Addendum #01

Project Name: Proposed Renovation and Addition: Ellisville City Hall and Police Station

Project Number: 20016

Date: 2023-03-17

1 ROOF LEVEL - MECHANICAL
1/8" = 1'-0"

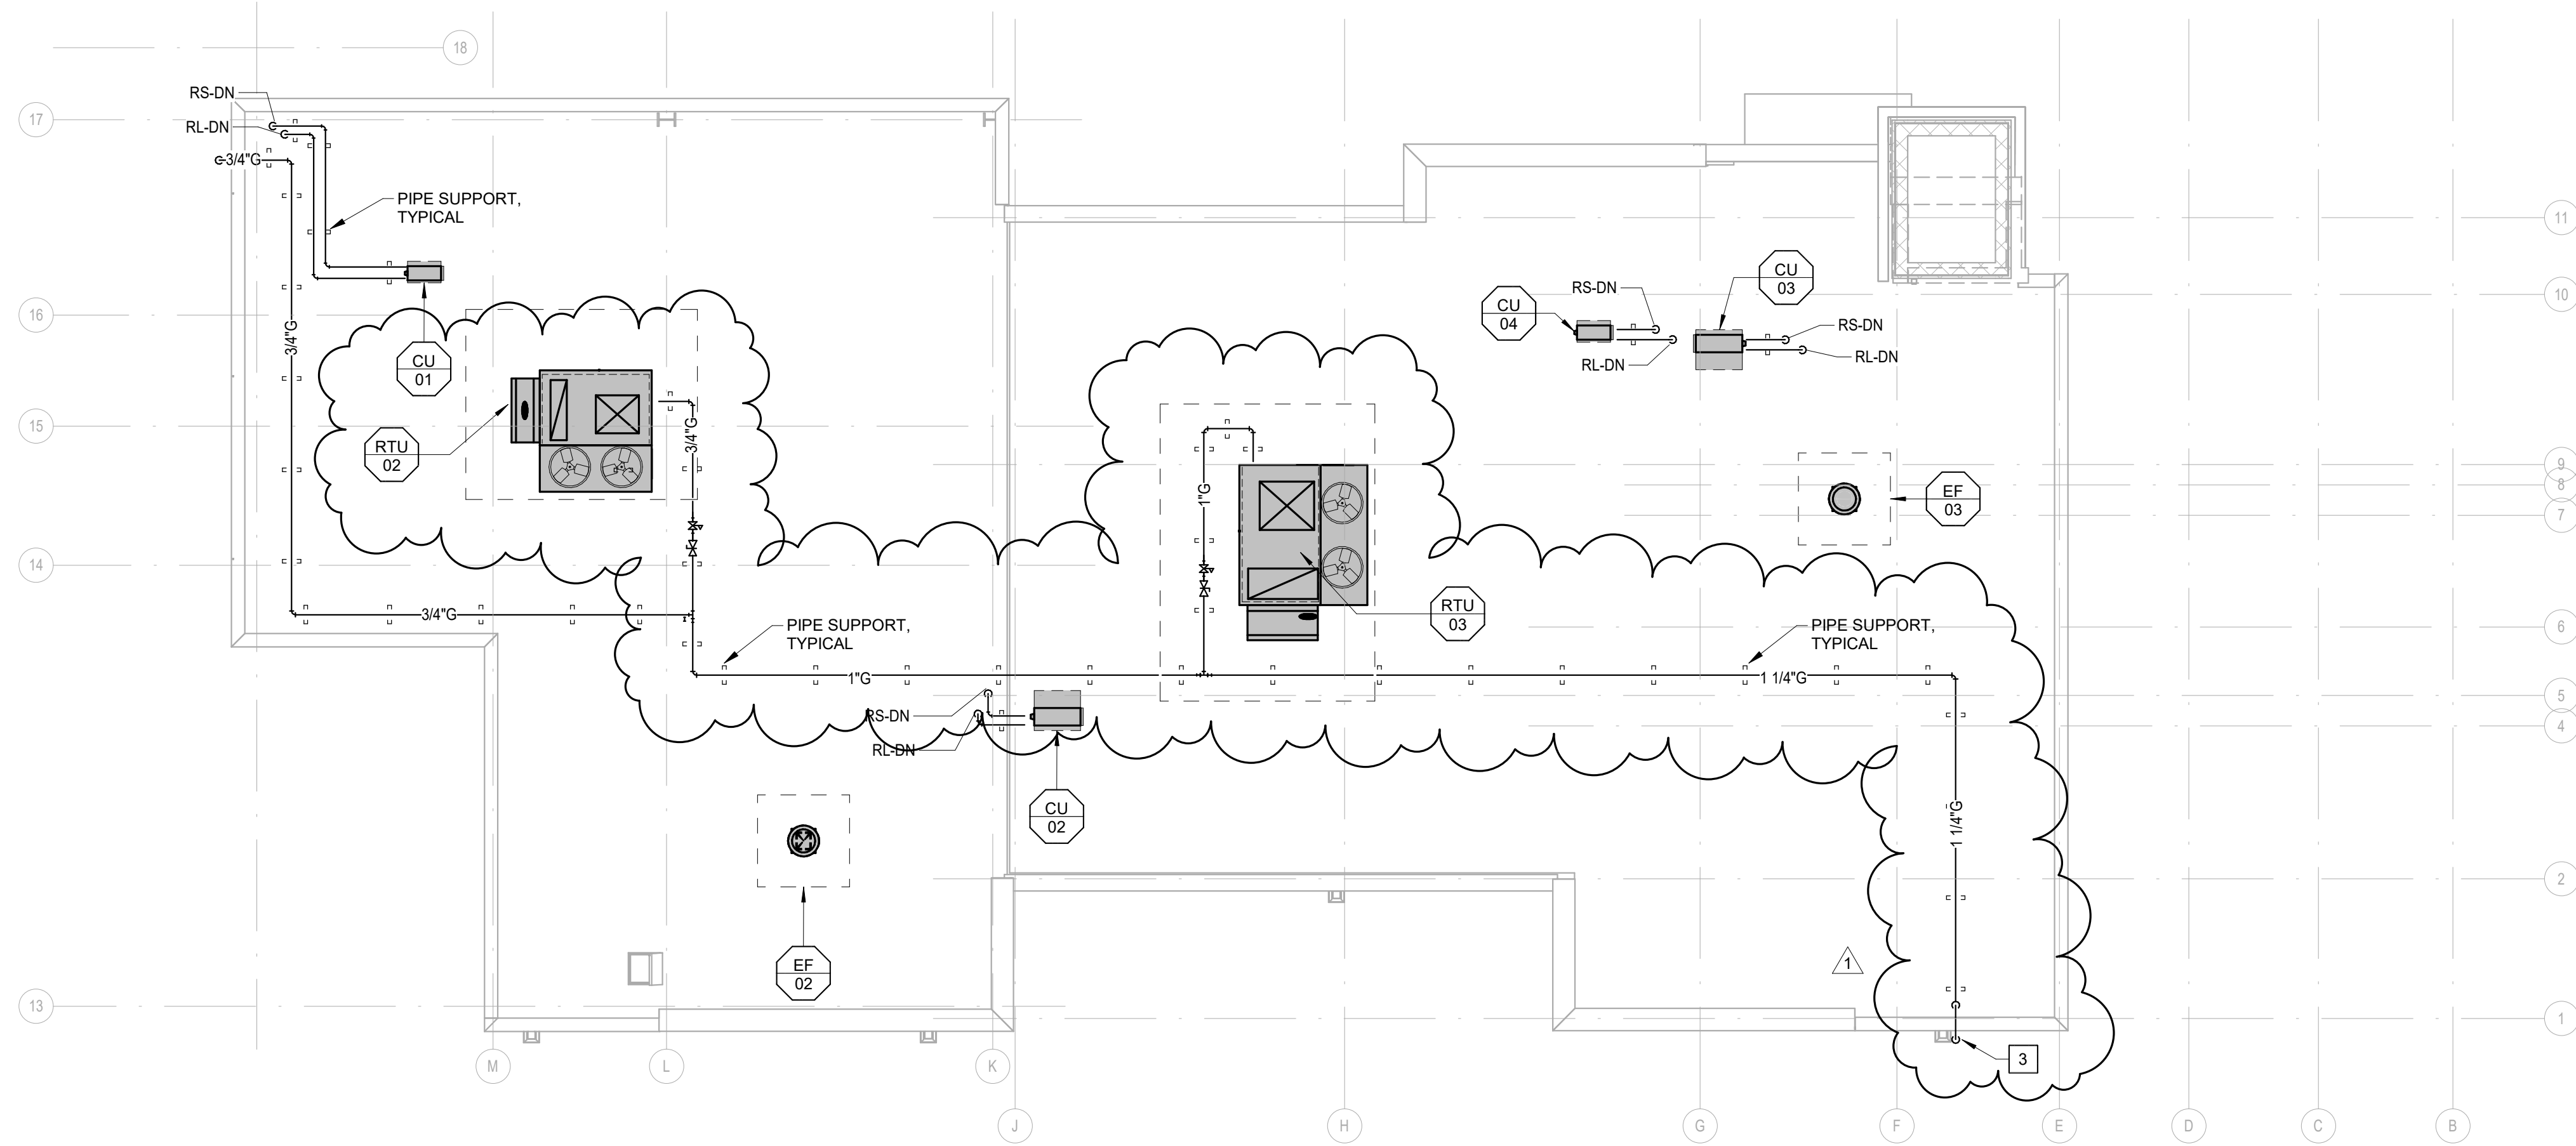
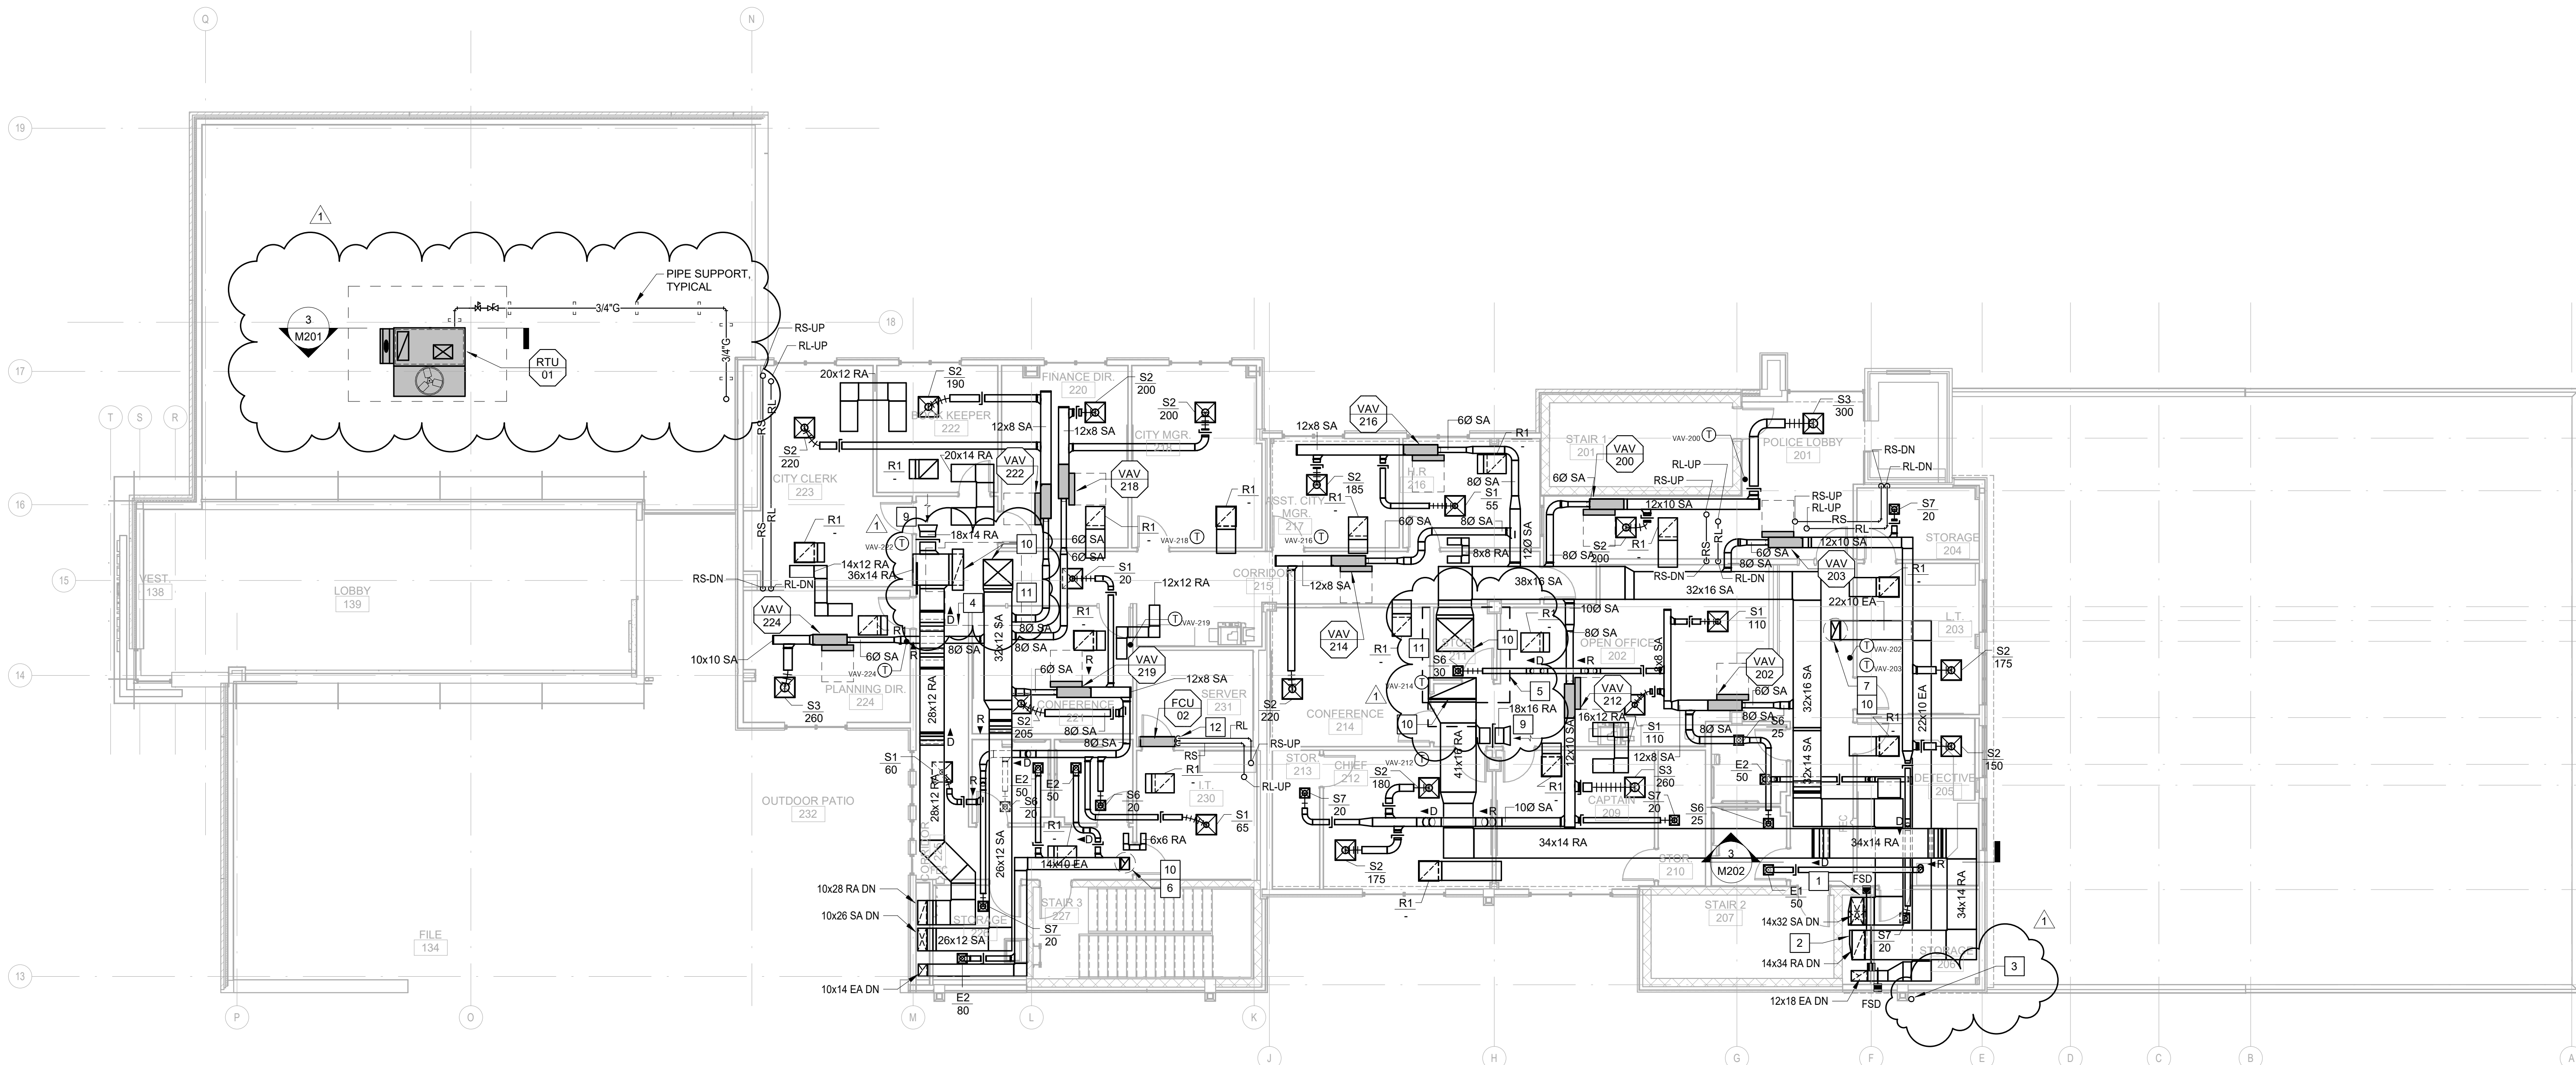
- a. **Updated gas line size for increase in MBH from new RTU selections on plan view.**
 - b. **Updated gas line routing on plan view for new RTU selections on plan view.**

- c. **Updated Keynote for gas line size for increase in MBH from new RTU selections.**
 - d. **Reference attached Revised Sheet.**

1 ROOF EQUIPMENT POWER PLAN
1/8" = 1'-0"

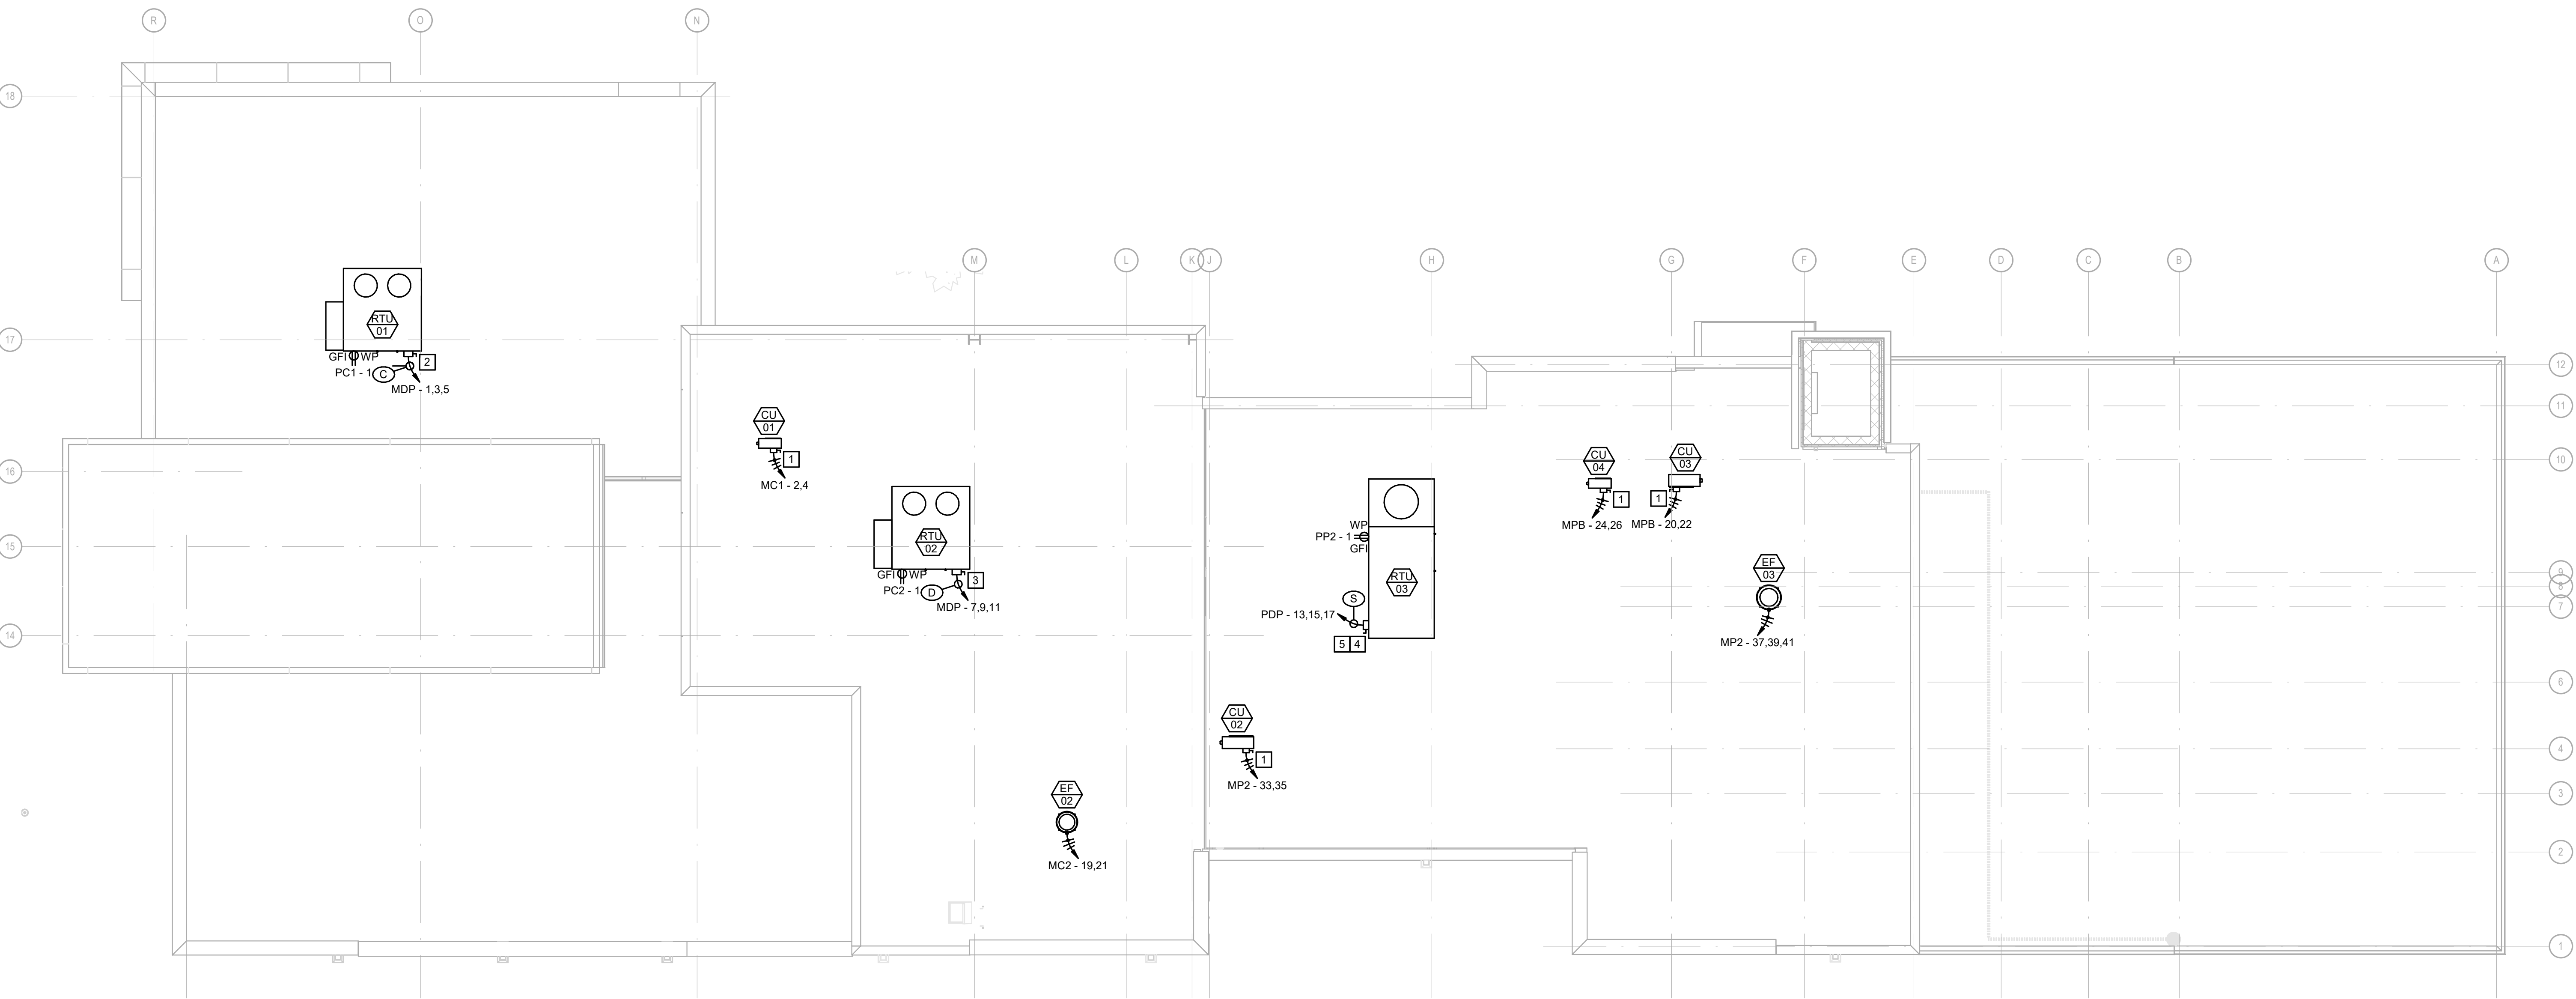
1. Sheet E211: Roof Equipment Power Plan
 - a. Modify Safety Switches for Rooftop Units.
 - b. Reference attached Revised Sheet.
2. Sheet E303: Partial level 1 Lighting Plan
 - a. Changed fixture type in vestibule.
 - b. Reference attached Revised Sheet.
3. Sheet E305: Level 2 Lighting Plan-Alternative
 - a. Shifted two light fixtures.
 - b. Reference attached Revised Sheet.
4. Sheet E601: Electrical Schedules
 - a. Modified Panel LS and LS (Alternate).
 - b. Reference attached Revised Sheet.
